# Early Design Guidance Meeting #2

3020 NE 45th Street  
Seattle, WA 98105

10.03.2022 SDCI #3039209-EG

ENCORE  
ARCHITECTS

SECTION A-A - 3D VIEW:  
NEW PEDESTRIAN PLAZA  
ON UNION BAY PLACE NE

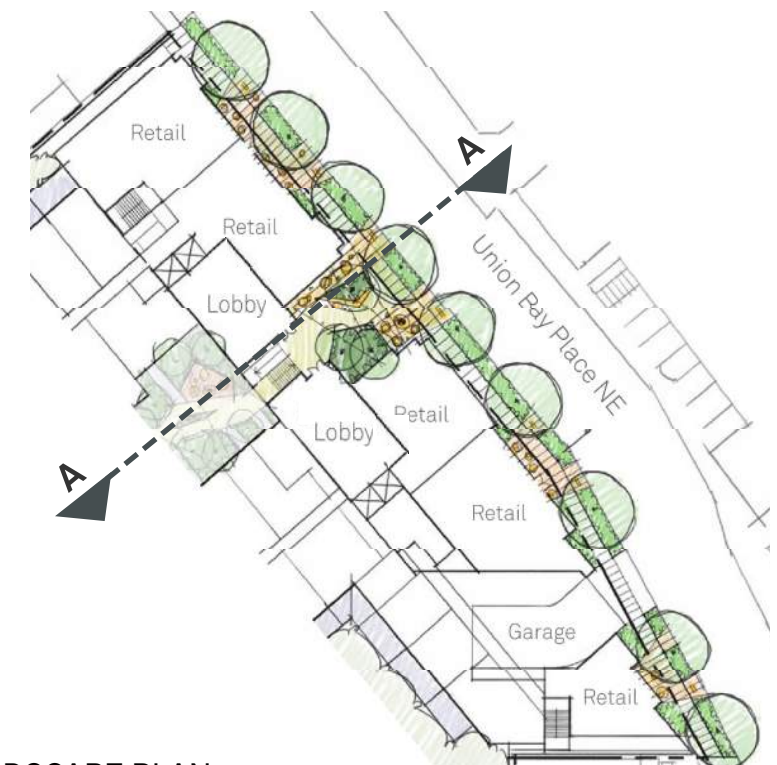
"The Board agreed that Option 3 (Focal Point), the preferred alternative, with its south facing plaza and focal point on the exceptional tree was the strongest massing alternative. However, the Board was unclear about how the upper-level parking entry along Union Bay functioned in relationship to the proposed retail spaces, the lobby and the existing buildings near the intersection and therefor asked for additional information, section, or studies for clarification. (CS2-B-2, PL1-B-1, PL1-1, DC2-D-1, DC4-D-2)."

To enhance the retail and pedestrian experience along Union Bay Place, the project has incorporated the parcel that previously divided the street level facade along this frontage. This allowed for the introduction of a new pedestrian plaza at street level, with the building lobbies and retail space fronting this plaza. This new plaza provides active open space and a pedestrian connection from the retail parking area separate from the vehicle entry. Both the north and east building lobby entrances have been relocated towards the interior of the plaza, allowing for more contiguous retail frontage along the sidewalk.

Project is now  
continuous across  
street frontage, with  
new pedestrian plaza

NE 45th Street Plaza / Courtyard: Added balconies, storefront.

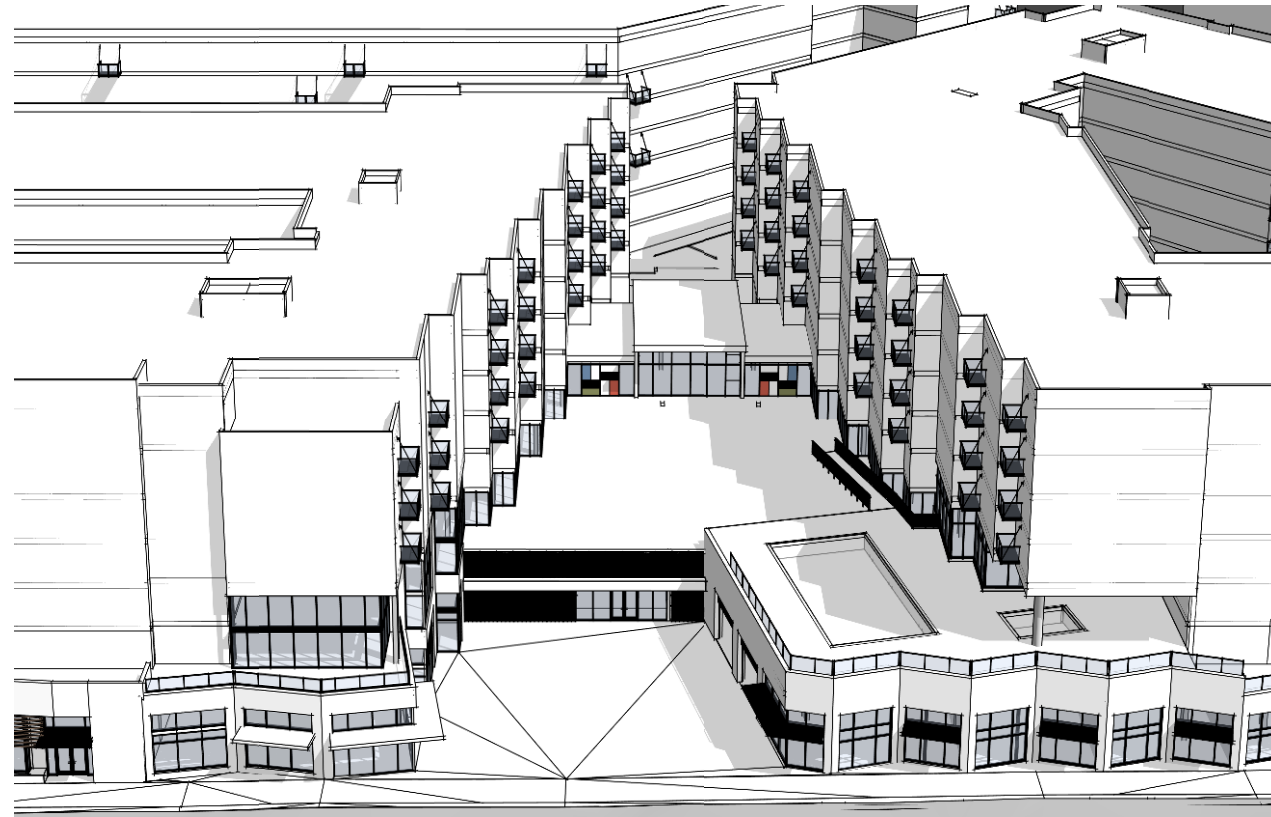
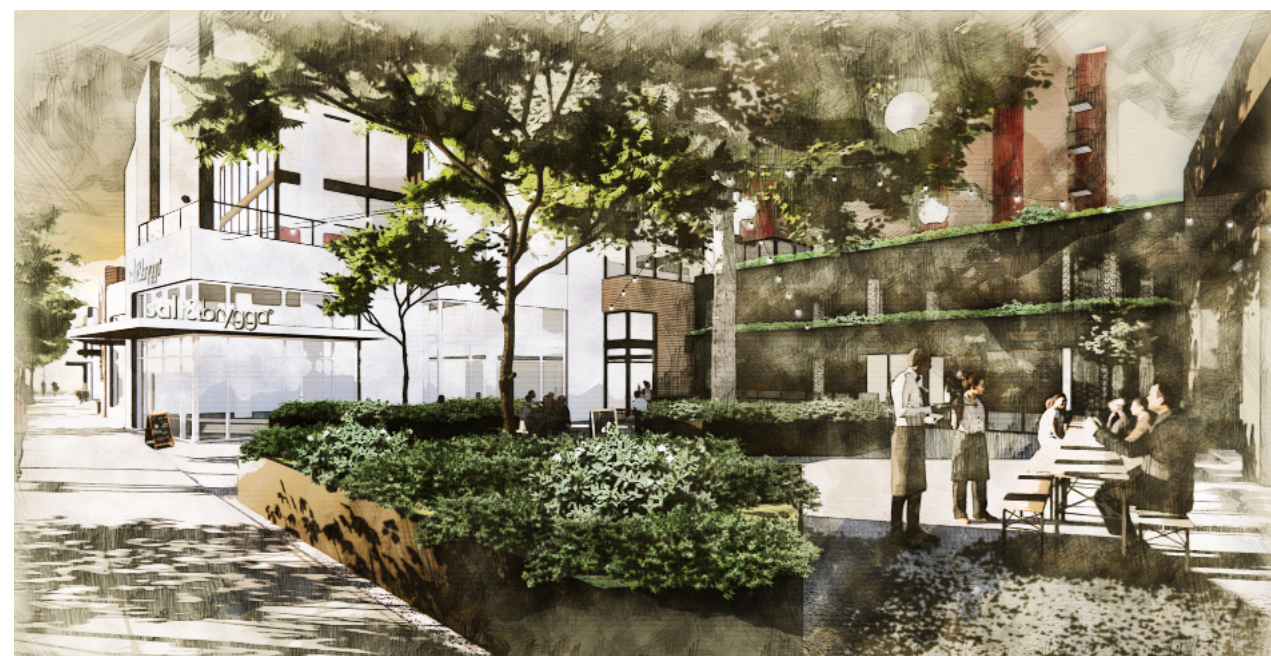
"The Board suggested that they would like to see how the application of materials and other elements like balconies will be developed as they evolve the design and move toward the Guidance phase. Members pointing to precedent imagery on page 71 of the EDG packet were hopeful that this type of application of balconies might be applied to the facades along Union Bay and 45th to add character to the building and take advantage of views. Board members also suggested that it would be nice to create that same type of articulation within the courtyard as well. (CS2-B2,CS3-1, PL1-A, DC4-B)."

The preferred massing scheme has been updated to include potential secondary architectural elements such as balconies and canopies (conceptual only - not representative of final quantity and/or locations). Concept sketches have also been created to suggest possible application of materials. These images are preliminary and will be further developed as the project moves toward the MUP application.

Union Bay Place Plaza: Added balconies, storefront.

View 1: U-Place facade facing project site

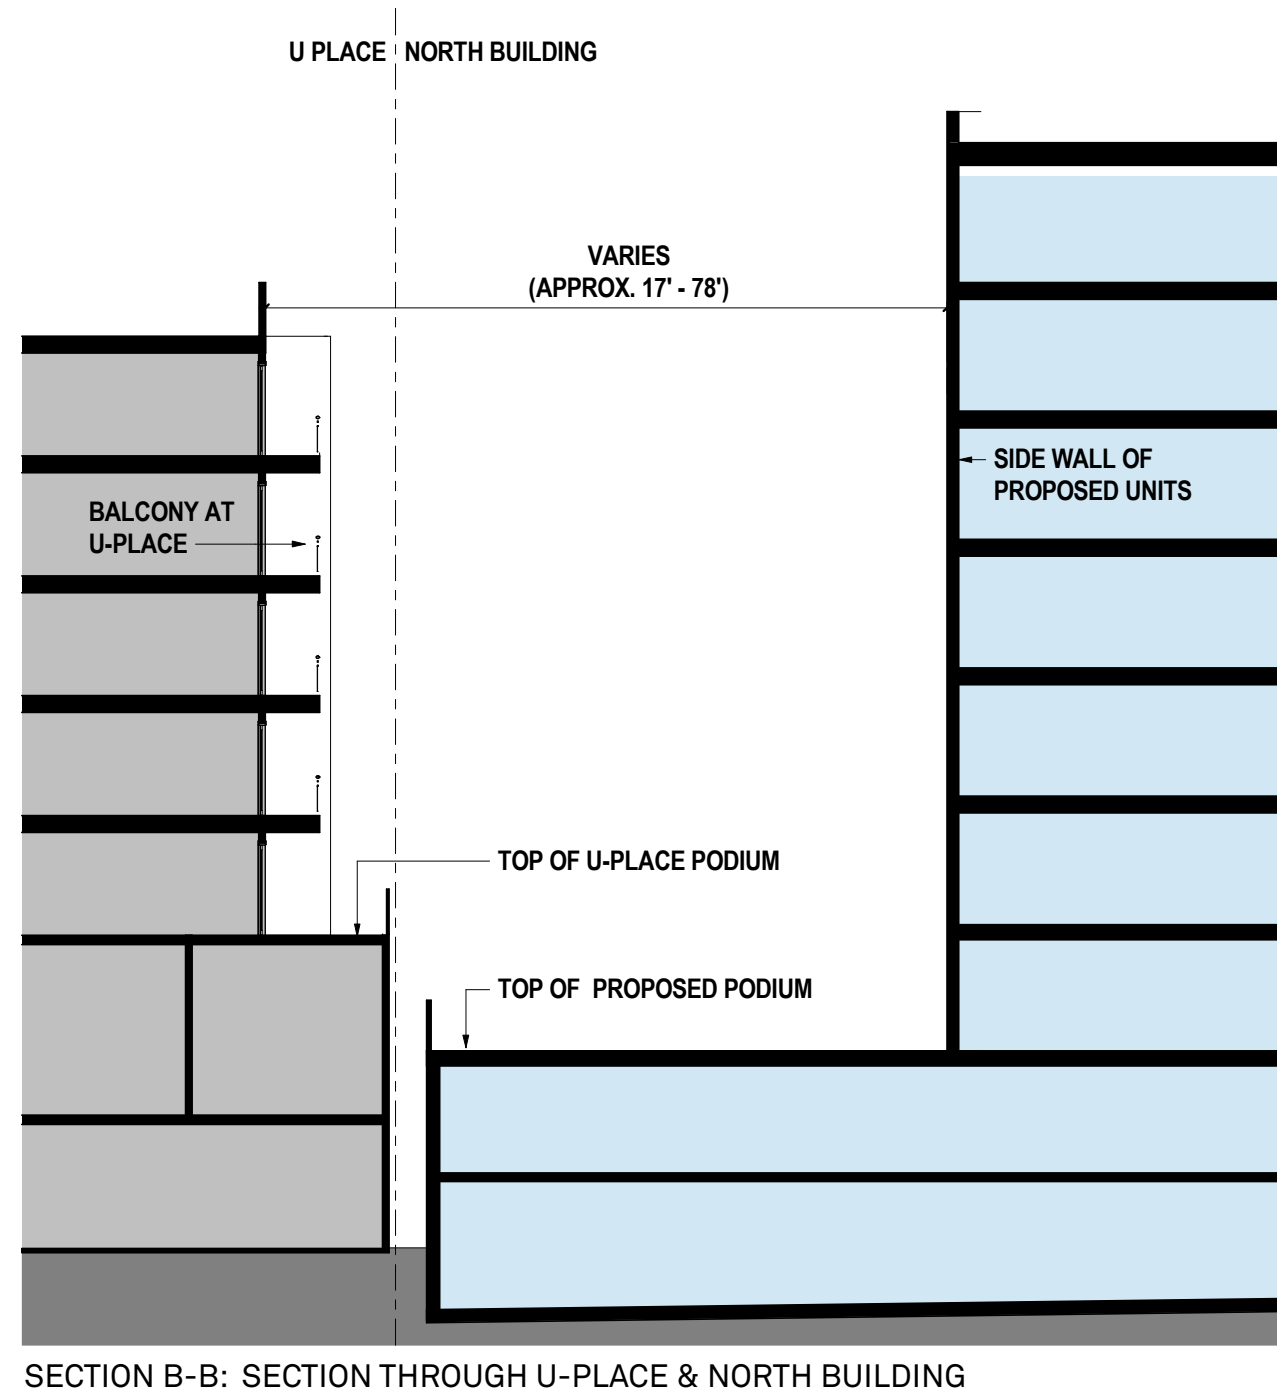
The Board recommended a more detailed study of the proposed project as it relates to the existing adjacent project to the north (U-Place).

The U-Place project's south elevation includes a combination of unit balconies and solid walls along the shared property line. The proposed project responds in kind to the U-Place building's configuration, setting back to provide courtyards along the north property lines that will provide relief, shared daylight, and views for both properties. Similarly, proposed solid walls are strategically located in relation to the existing solid walls of the U-Place project.

Section A shows both the U-Place project and the proposed project have a podium with solid walls in close proximity to the property line. The U-Place podium is higher than the proposed project's podium, approximately aligned with the proposed project's Level 4 floor line. Above the proposed project's podium level, from Levels 3 through Roof, the project is set back from the shared property line and provides a courtyard space that visually opens up to both properties. The proposed courtyard width varies from approximately 17' to 78' clear at the residential unit levels.

## Solar Study - Massing Comparison

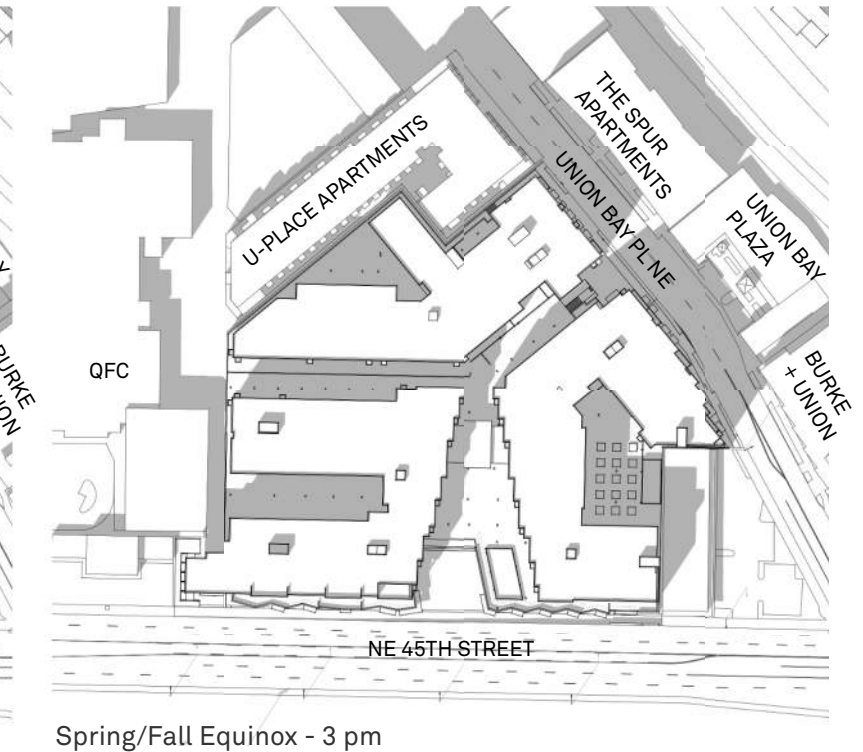
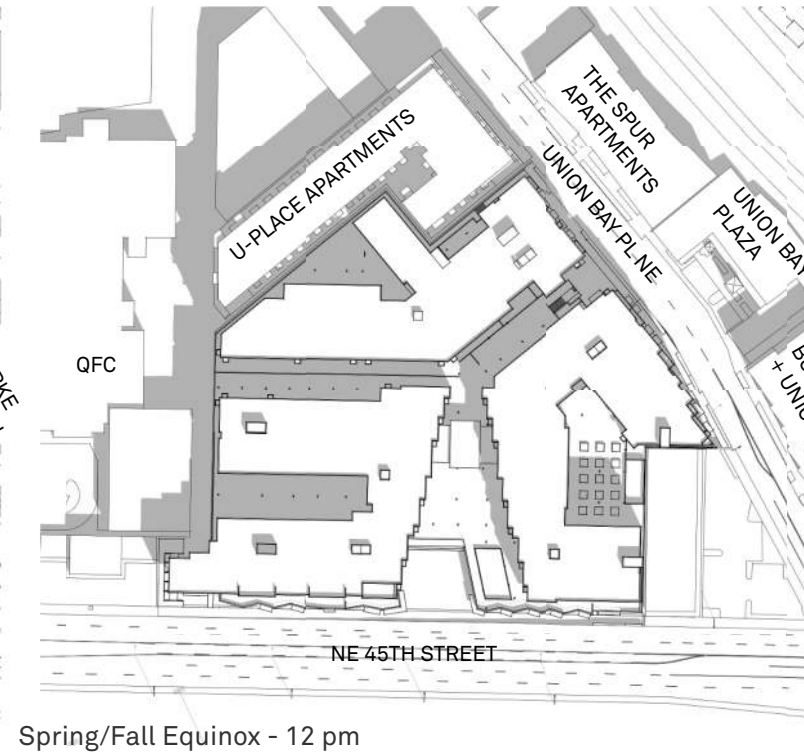
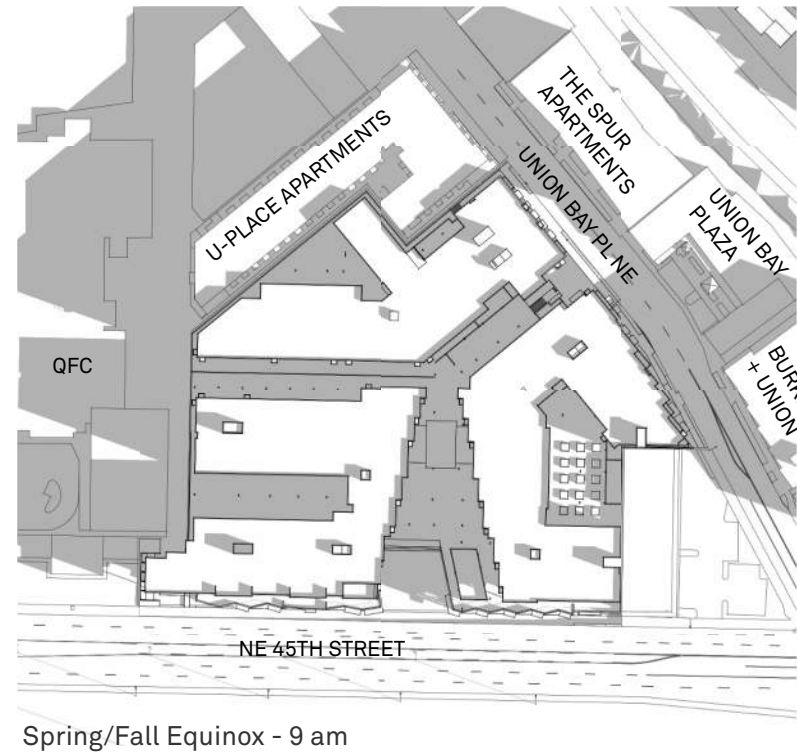
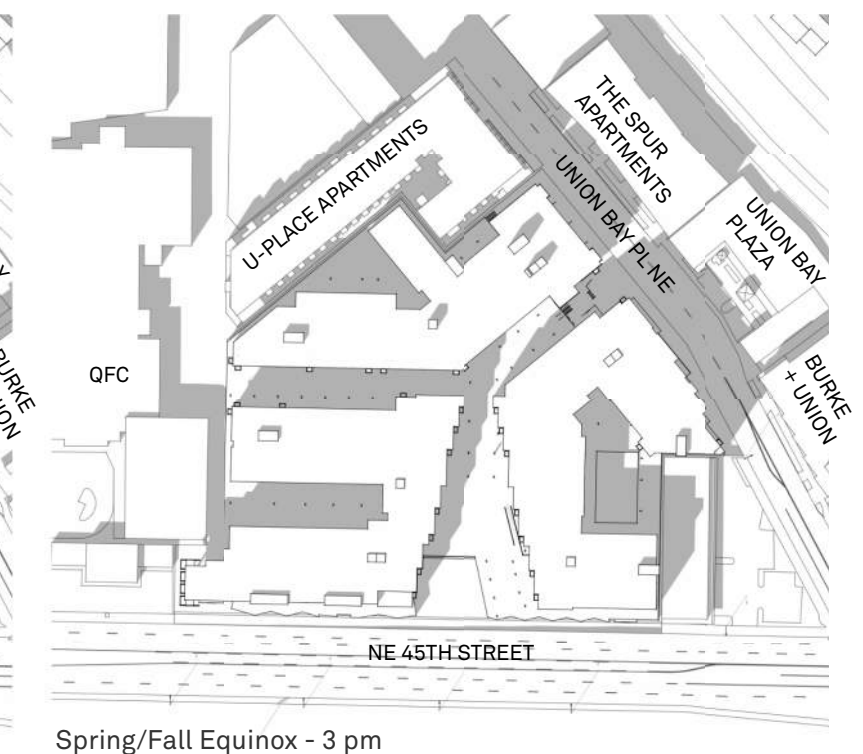
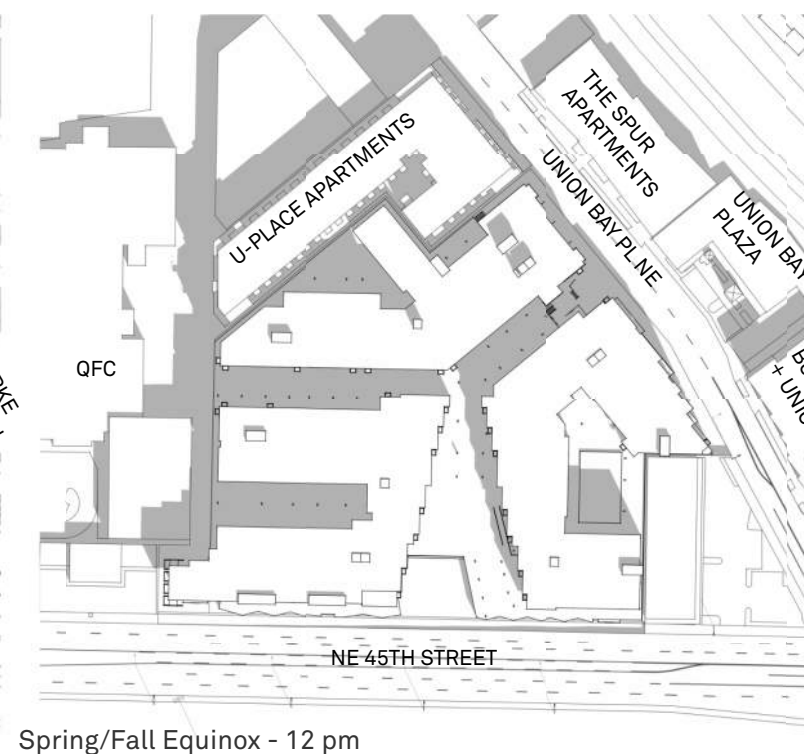
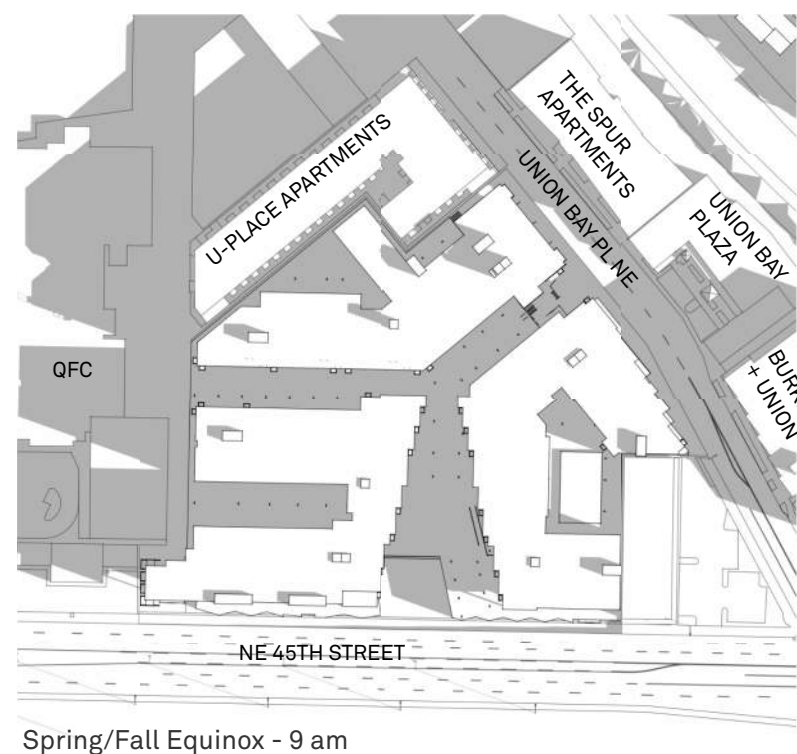
"The Board stated that they would need a stronger rationale as to why the additional height makes the design stronger. The Board also stated that they would need additional information about the design team's position that the perceived height of building with the added height would still only be 8 stories. As such the Board did not support this departure. CS2 - Urban Pattern and Form, DC2-B Architectural and Facade Composition, CS2-D Height, Bulk and Scale, CS2-2-b. Provide Zone Transitions."

Comparison of solar shading of proposed project both with and without the additional floor at the north building per the departure request.

## Iteration B - No Departure Request: Development Without Additional Height and Without Retaining Existing Exceptional Trees

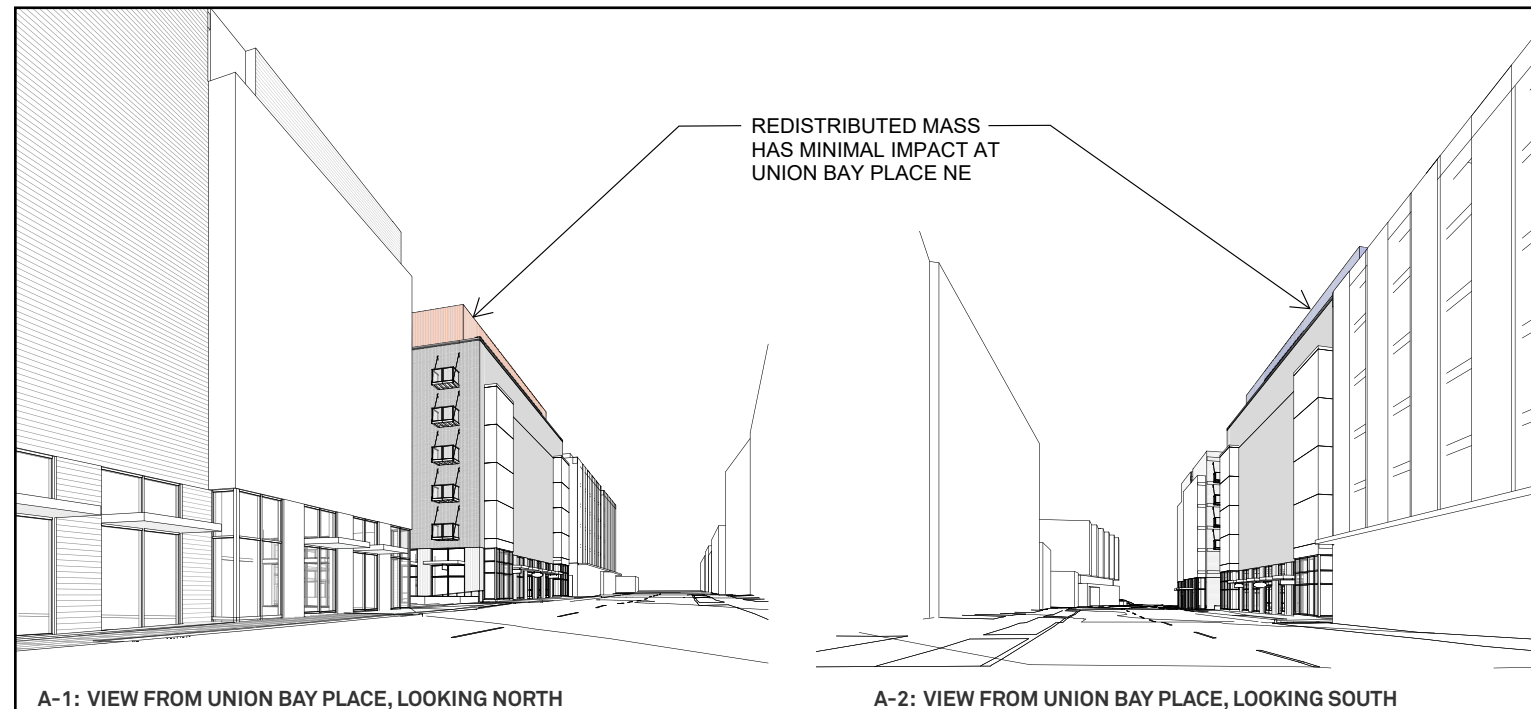
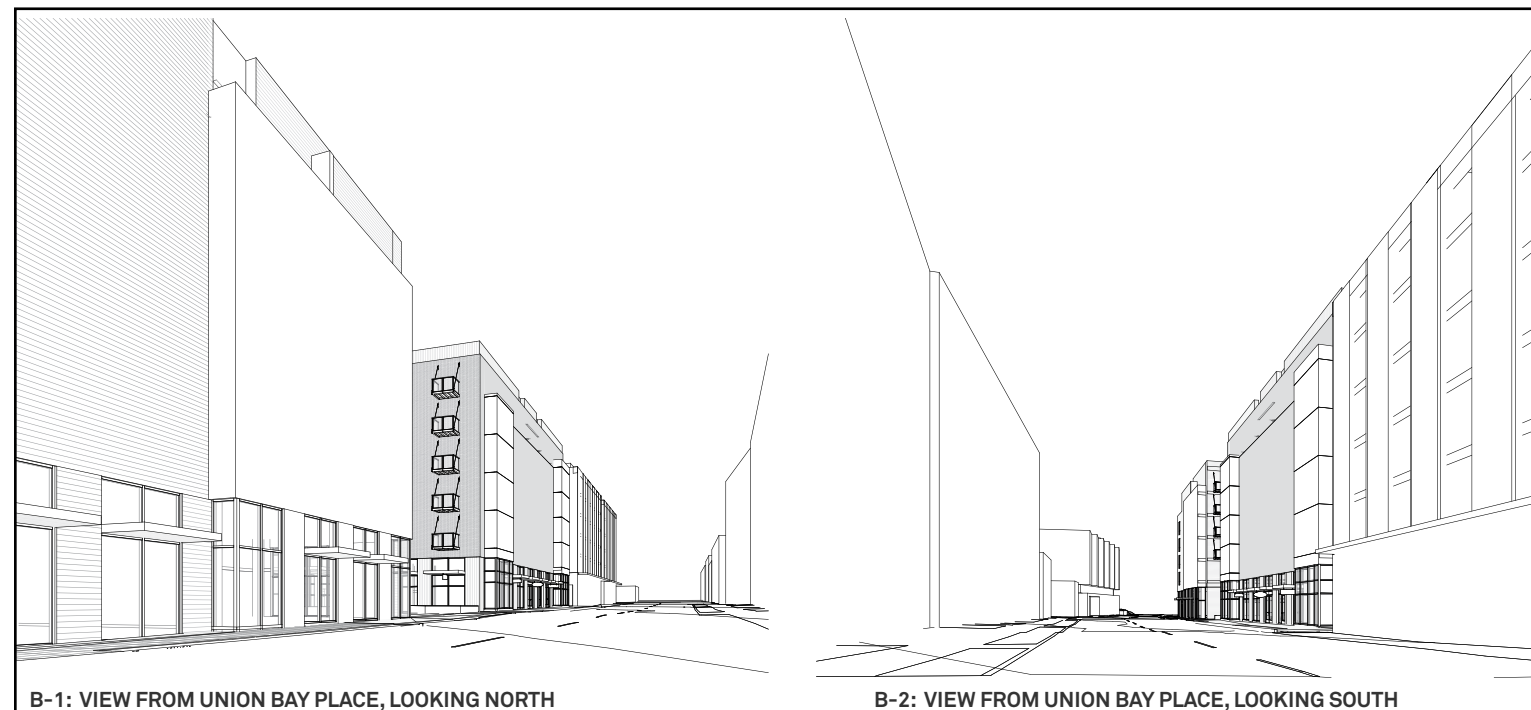
The Board stated that they would need a stronger rationale as to why the additional height makes the design stronger. The Board also stated that they would need additional information about the design team's position that the perceived height of building with the added height would still only be 8 stories.

Iteration B shows the massing if no zoning height departure is granted. Without the additional height, the massing configuration redistributes the residential square footage from the proposed additional floor of the North Building to the 3rd through 8th floor of the East and West Buildings.

The redistributed square footage results in approximately 5,500 square feet added per residential floor. The width of the plaza on NE 45th Street is reduced (see Site Plan B on previous page), and the perceived bulk and scale of the building is increased.
